# Environmental Impact Assessment

## Screening according to Schedule III of S.L. 549.46

<b>ERA Reference no.:</b>	EA/00052/20
<b>PA Reference no.:</b>	PA/02262/20
<b>Project Title:</b>	Construction of two storey car park for 506 small to large private vehicles and bike park.
<b>Location:</b>	Site at, Ta' Qali, Attard
<b>Screening date:</b>	January 2021

Figure 1: Block plan showing existing trees and structures (Source: E-apps doc PA2262/20/64d)

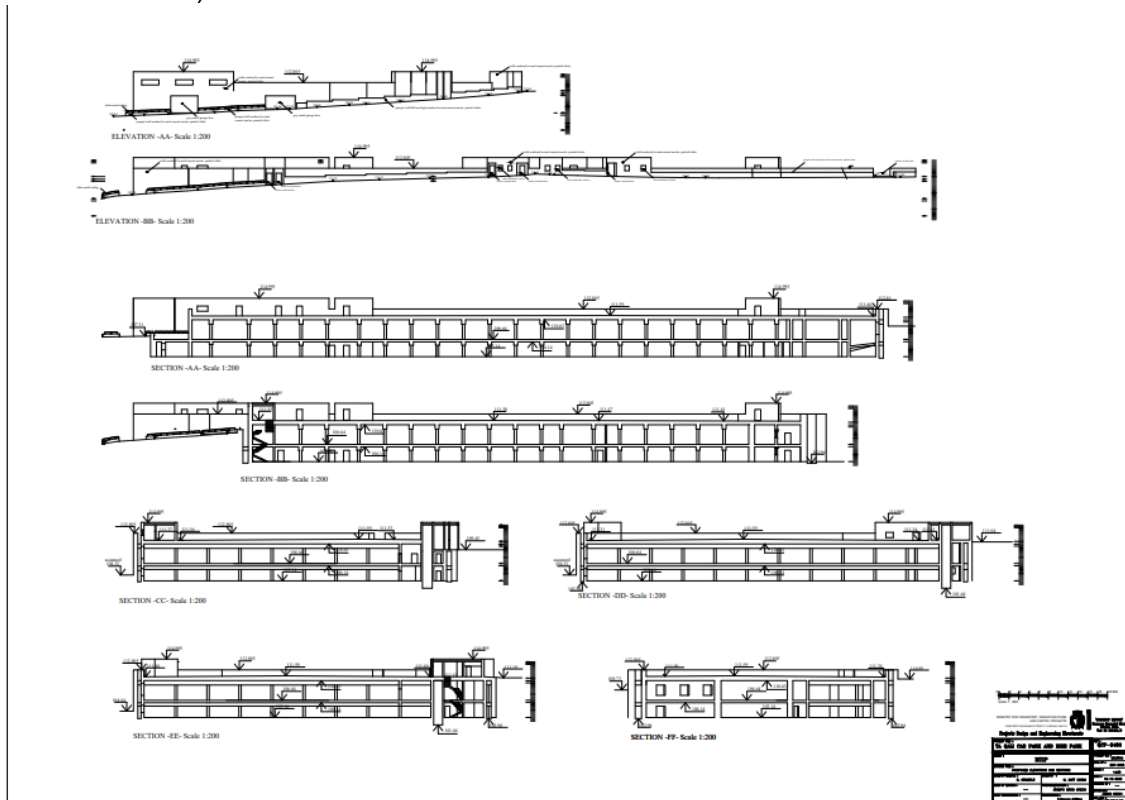
6.3 Within the proposed site, there are 23 trees (of which 15 are protected) which will be removed. A nature permit for tree uprooting and compensation planting has already been submitted to ERA and is currently pending further information. In this regard, no significant impact is being envisaged.

6.12 The site contains six Nissen huts which are historic military structures which were used during the World Wars and thus have a degree of cultural heritage value. Therefore, as also stated in the Superintendence of Cultural Heritage (SCH) consultation reply on E-apps (doc. 53a), these should be dismantled and relocated. In view of this, direct consultation with the SCH is to be undertaken.

Figure 2: Proposed elevation and sections (Source: E-apps doc PA2262/20/67e)

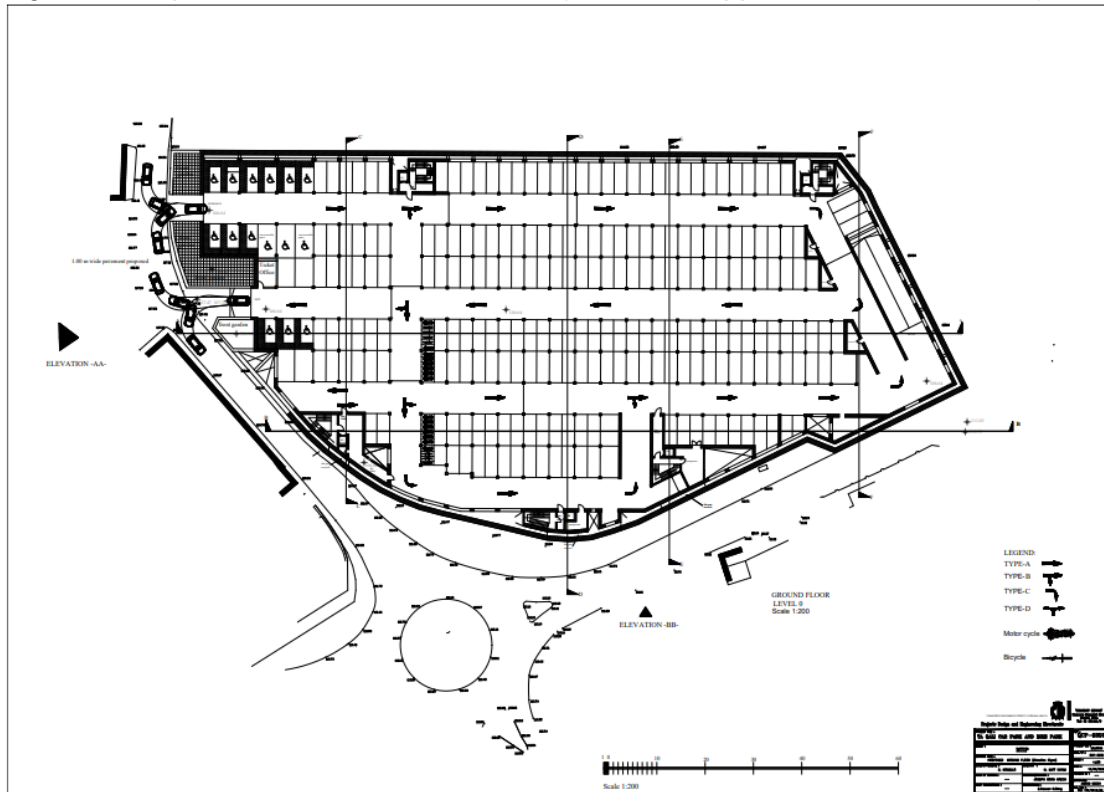
6.2 Even though the proposal will be visible from the main road, mainly due to its height, the site is not considered sensitive from a landscape point of view. Given the location of the project, no significant impacts are being envisaged.
